Subject: INFORMATION: Guidance for Demonstrating
Compliance with Seat Dynamic Testing Deceleration
Pulse Shapes

Date: NOV 19, 1997

From: Manager, Transport Airplane Directorate, Aircraft
Certification Service, ANM-100

Figure 5

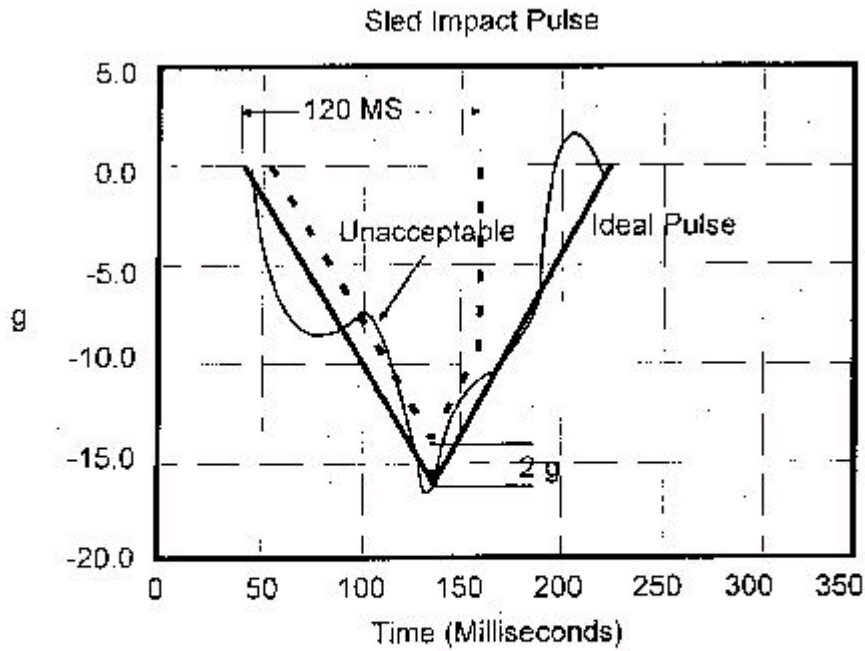
As an example, the 16 g test specified for Test 2 in § 25.562 of the FAR has rise time, (T₃-T₁), of 90 milliseconds. For a test pulse to be in compliance with the 16 g test pulse, the magnitude of the acquired pulse can be no less than 2 g from the ideal pulse during the time interval from $T_1 < t < (T_1 + 120)$ milliseconds. The acquired pulse shown in Figure 5 is unacceptable because the acquired pulse magnitude

is more than 2 g below the tolerance band during the onset period. (Note that, because deceleration is expressed as a negative number, the graph below is inverted, with magnitude increasing in the downward direction from the reference.

"6. Construct a line parallel to the ideal (minimum regulatory requirement) pulse and offset by 2 g in magnitude less than the ideal during the time interval between T₁ and T₃. Likewise construct a line parallel to the ideal pulse and offset by 2 g in magnitude less than the ideal (minimum regulatory requirement) pulse on the trailing side of the pulse from:

$$T_3 < t < T_1 + 1.33(T_3 - T_1)$$

If the magnitude of the acquired pulse is 2 g less than the ideal pulse shape at any point along the acquired pulse shape during the period $T_1 < t < T_1 + 1.33(T_3 - T_1)$, the pulse is unacceptable.

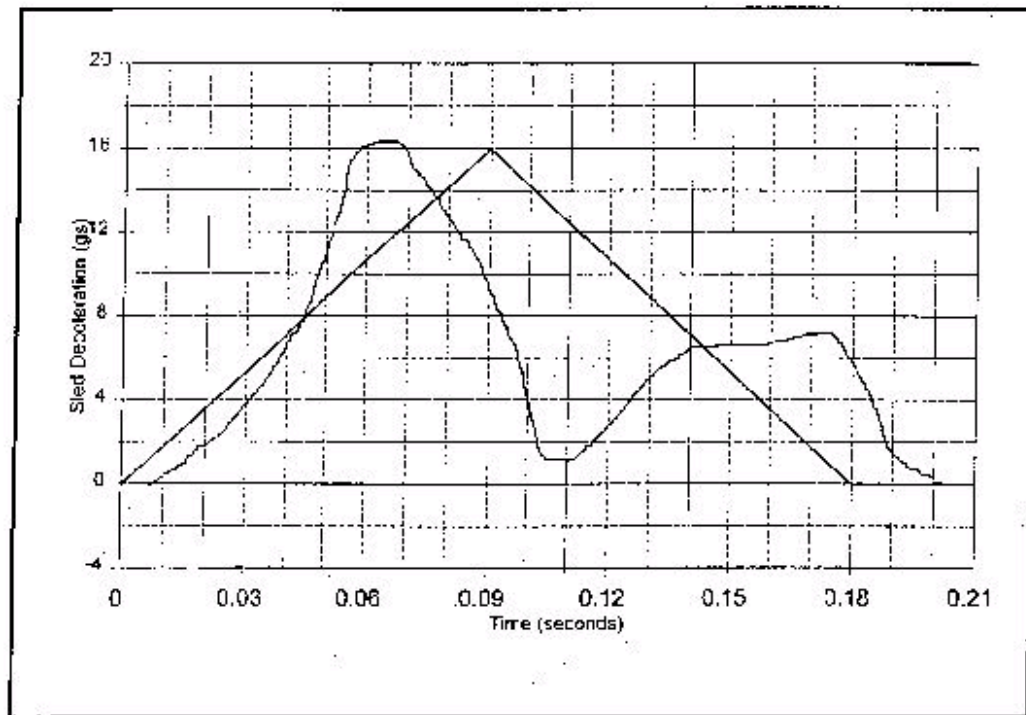
Recently, we have seen test pulses that, while they may satisfy the graphical evaluation procedural methods in Appendix 1 of the AC, do not resemble an isosceles triangle. An example of such a pulse is attached for information. Taken to its extreme, a pulse with an instantaneous peak g of the correct value, followed by a rectangular pulse of the specified duration at one half the peak value would satisfy the graphical procedure in the Appendix. Clearly, this type of pulse is not triangular, would impart a much less severe load on the seat, and would not meet the intent or the minimum requirements of the regulation.
